# Modification Notice - Regulation 22

<b>Interest Holder</b>	Central Petroleum Limited	<b>EMP Title</b>	Palm Valley Development Wells	<b>Unique EMP ID No.</b>	CTP10-2	<b>Mod No.</b>	1	<b>Date</b>	11/02/2026
<b>Brief Description</b>	<p>This modification seeks approval to refine and reduce the approved clearing footprint at the New York Junction access connection. The modification reflects updated spatial planning with supporting environmental and cultural heritage assessments that constrains clearing to only what is operationally required for safe road access by both light and heavy vehicles, the installation of additional pig launcher / receiver and associated infrastructure and hazardous area compliance and surface facilities. Ultimately the proposed change to the clearing footprints results in a net reduction in environmental disturbance. Ecological Assessment is provided in Appendix 1 and Heritage Assessment is provided in Appendix 2.</p> <p><b>Key changes (refer to Appendix 3):</b></p> <ul style="list-style-type: none"> <li>▪ Removal of 242.4 m<sup>2</sup> of previously approved clearing area.</li> <li>▪ Defined road opening footprint of 462.7 m<sup>2</sup>.</li> <li>▪ Additio

**PLATE 1:** Drone image of proposed road opening area. Red polygon approximately depicts boundary of proposed road opening area. Drone photograph orientation: Southwest.

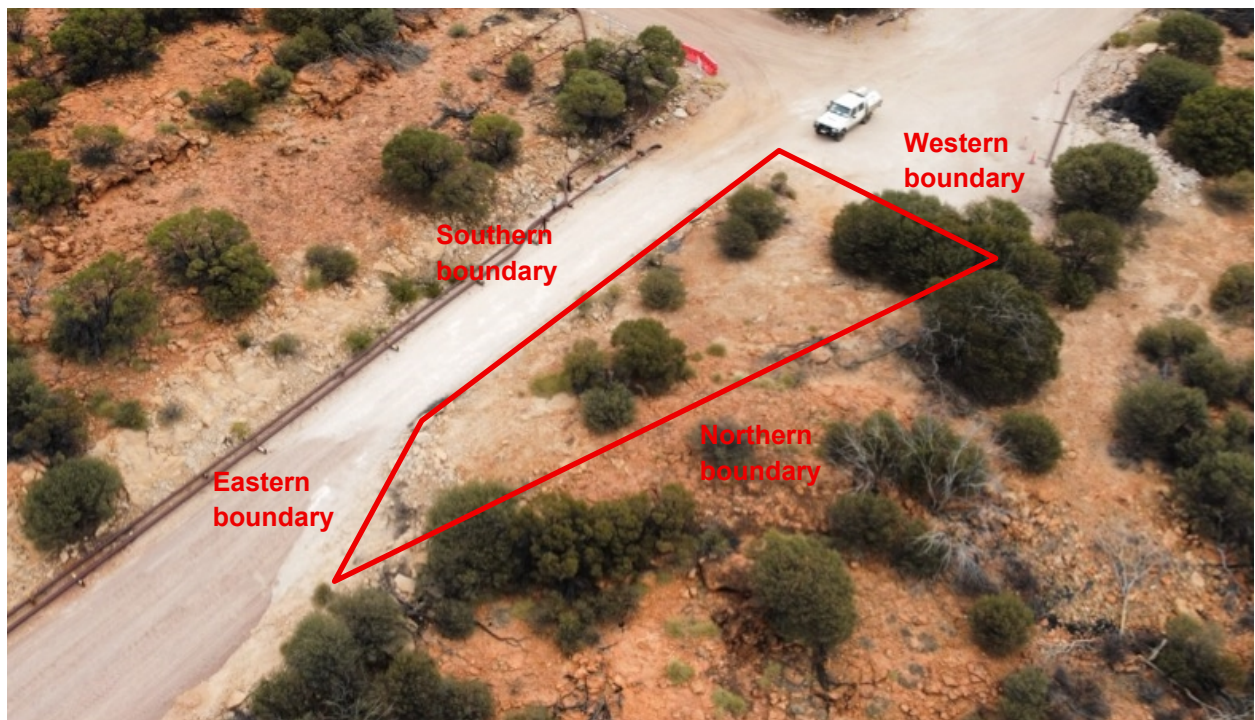
Onsite photographs indicate the selected works area has gentle slopes with large areas of exposed surface rock, with minor outcropping only.

The site has also likely been subject to previous ground disturbance due to its close proximity to existing road, presence of small Hill Mulga (regrowth), and white colouration of surface rocks, which is often present when sandstone material is crushed / disturbed. However, it is possible that a small section on the northern side of the selected area has not been previously disturbed as surface rock in that area has an orange/brown colouration.

Figure 1: New York Junction- Proposed road opening area.

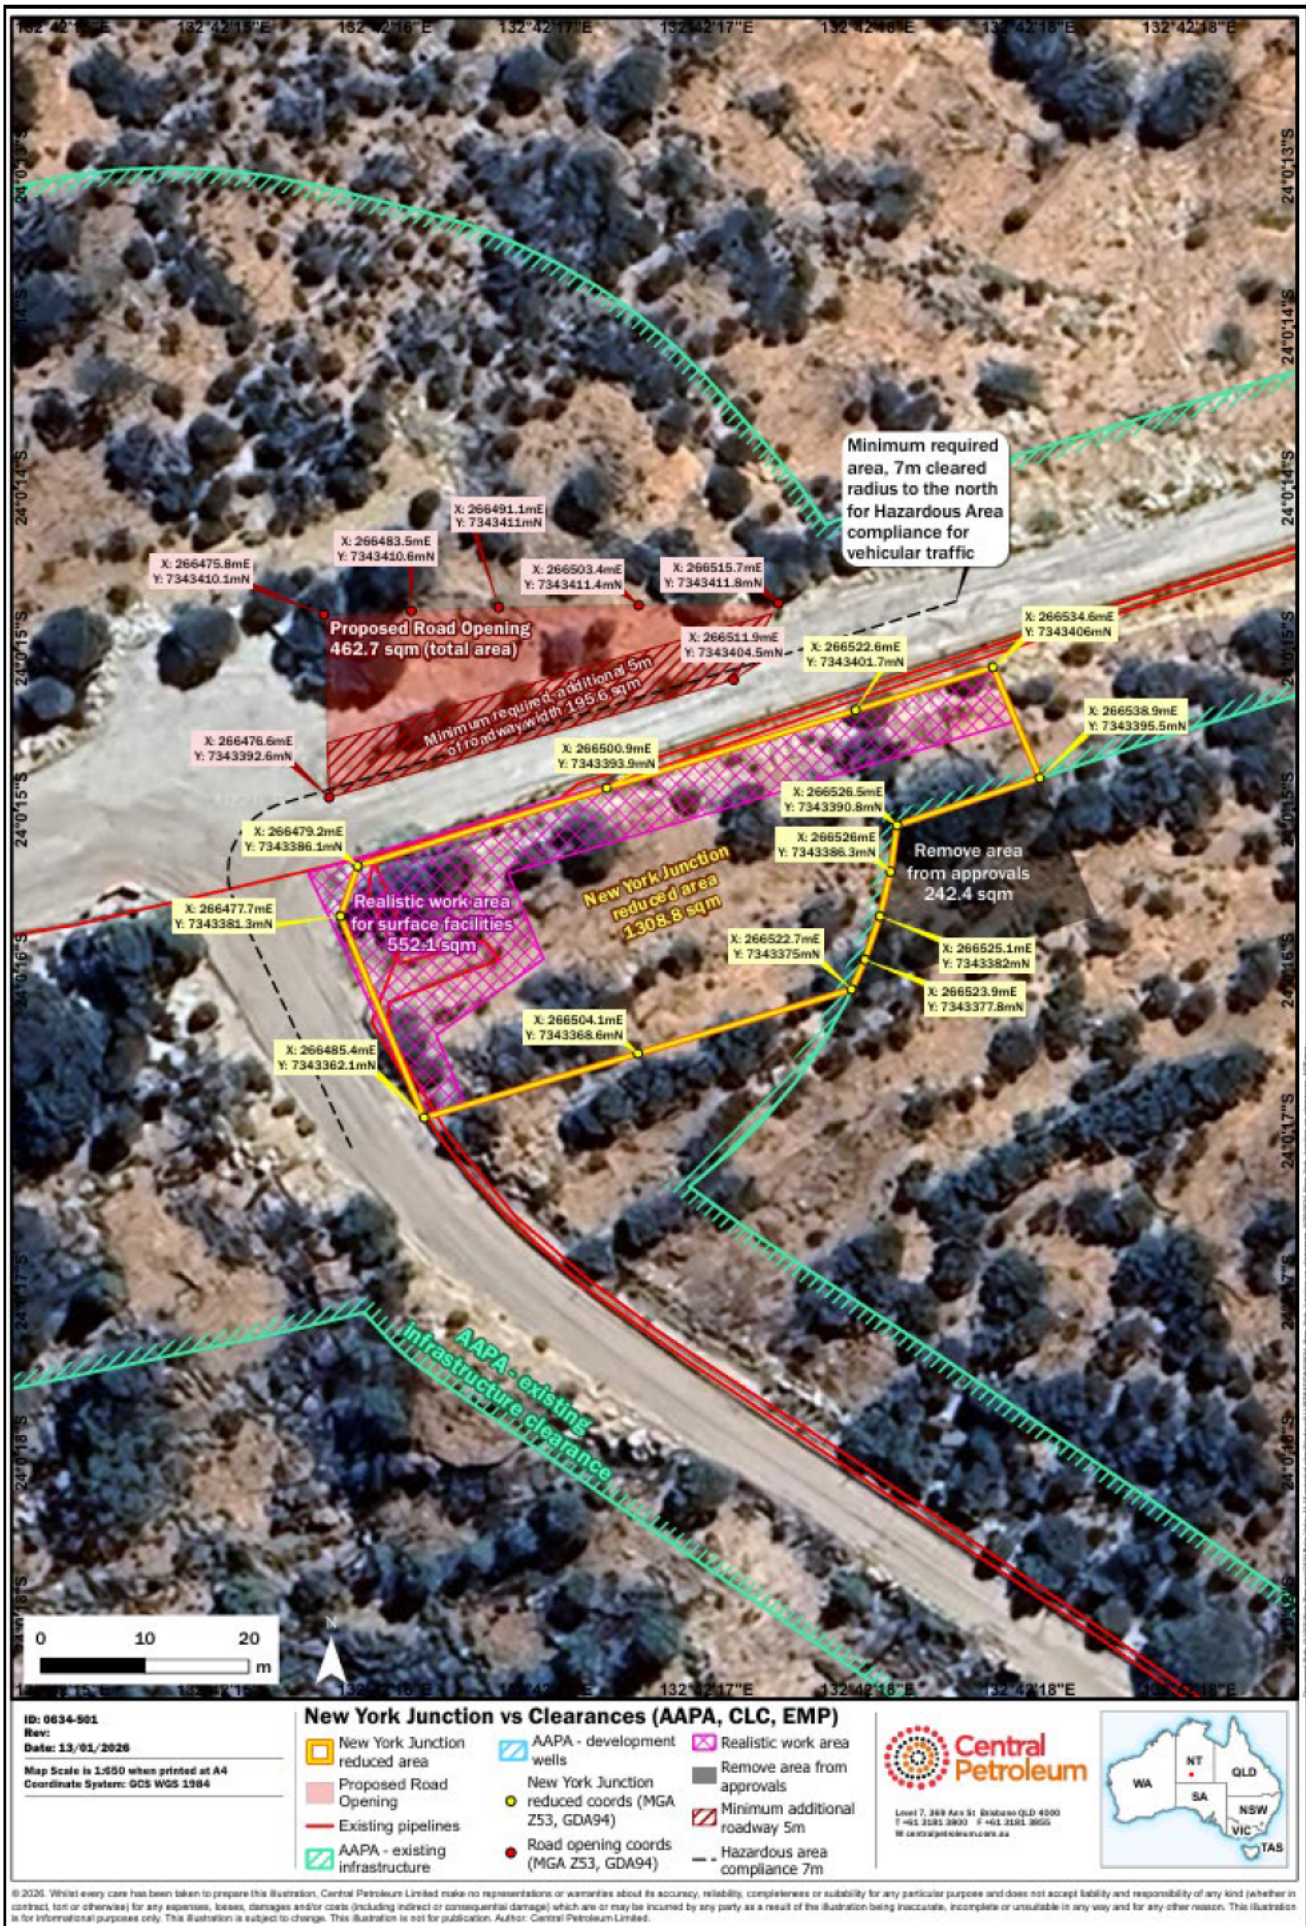
The proposed road opening works will require a cleared pad approximately 10 x 40 m on the northern side of the existing road (refer to red shaded area in Map 1).

Further to your request for specialist archaeological advice on the approval requirements for the proposed widening of the road access at 'New York Junction', between the PV14 and PV15 well sites (see below). Please see below statements relating to Aboriginal archaeological approval requirements to support the application for the amendment to the Environmental Management Plan (EMP).

Based on the review of the photos provided, it is not considered that additional [REDACTED] is required prior to amendment of the EMP/ approval. The area of the road widening is considered to have an overall low potential for [REDACTED]. If present, [REDACTED] [REDACTED] would be restricted to isolated finds with limited conservation significance.

Appendix 3 - Key changes to approved clearing footprint at New York Junction

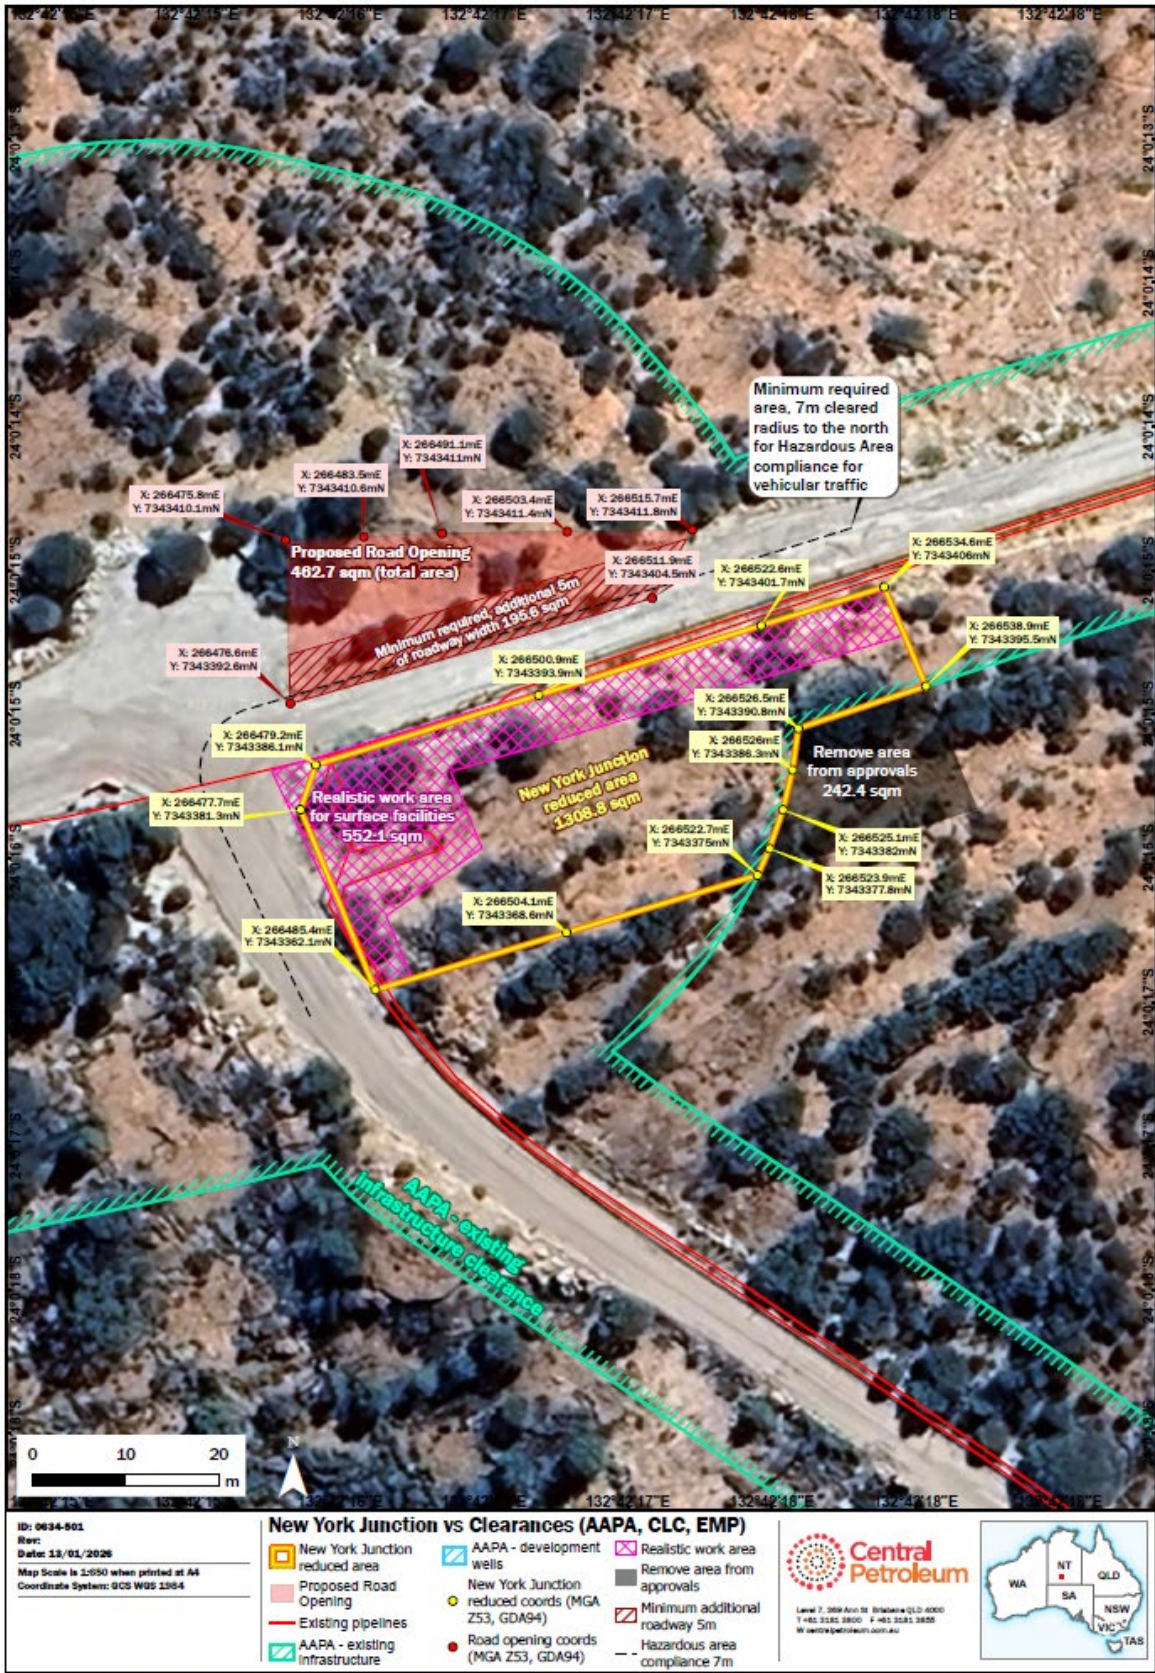
- Reduction of the approval area for the ancillary area south of the access road/ flow pipe, and
- Excavation into the ridgeline to facilitate widening of the access road to the north away from the ancillary area.
